LOT NO. 72 (Re-site)

BAYVIEW WELLINGTON

13049-SP-NEW ENTRANCE

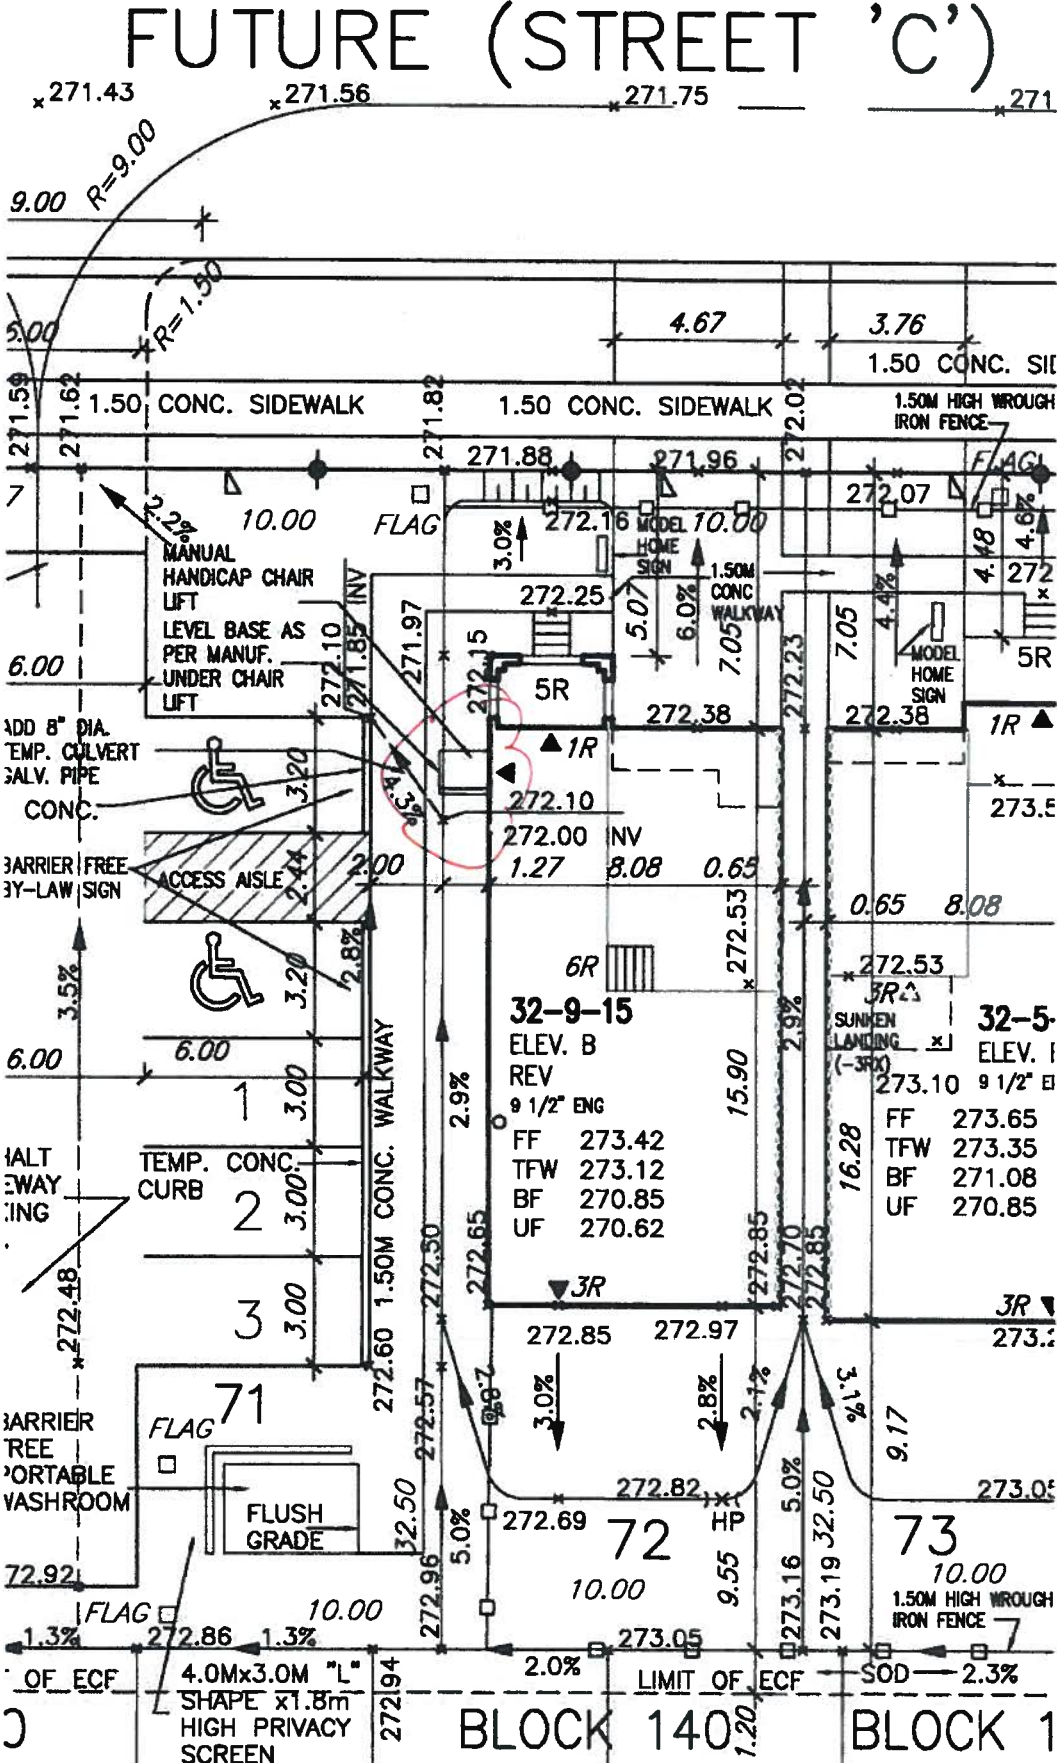
URBAN ECOSYSTEMS LTD. HAS REVIEWED THE PROPOSED GRADES AS SHOWN ON THIS PLAN AND HAS FOUND THEM TO BE IN GENERAL CONFORMANCE WITH THE APPROVED PLANS

* PER N.S. - LIFT TO BE REMOVED PRIOR TO OCCUPANCY OF SINGLE FAMILY DWELLING. & DOOR TO BE INFILLED TO MATCH WALL TYPE.
